## PLANNED UNIT DEVELOPMENT

& SUBDIVISION STAFF REPORT Date: June 5, 2008

**DEVELOPMENT NAME** Springhill Place Subdivision, Revised

**LOCATION** West side of Bishop Lane North, 100'± North of Broadway

### SITE PLAN

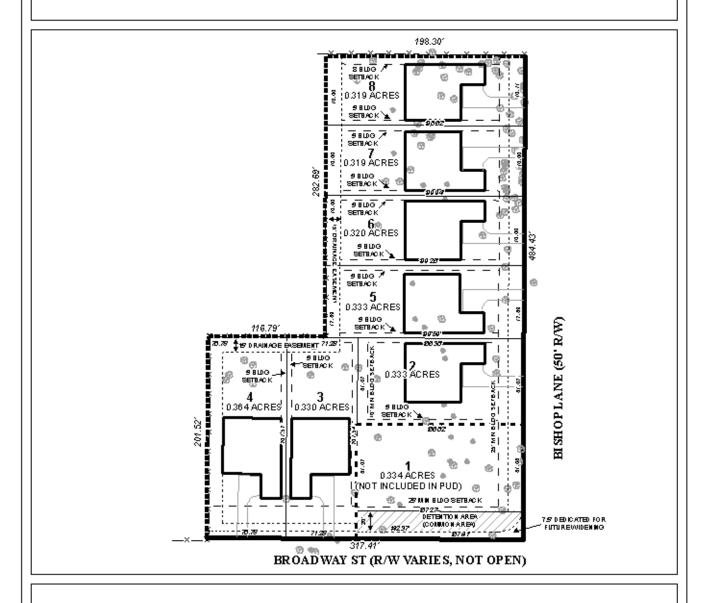
This site plan illustrates proposed structures and lot configuration.

Lot 1 is not included in the planned unit development.
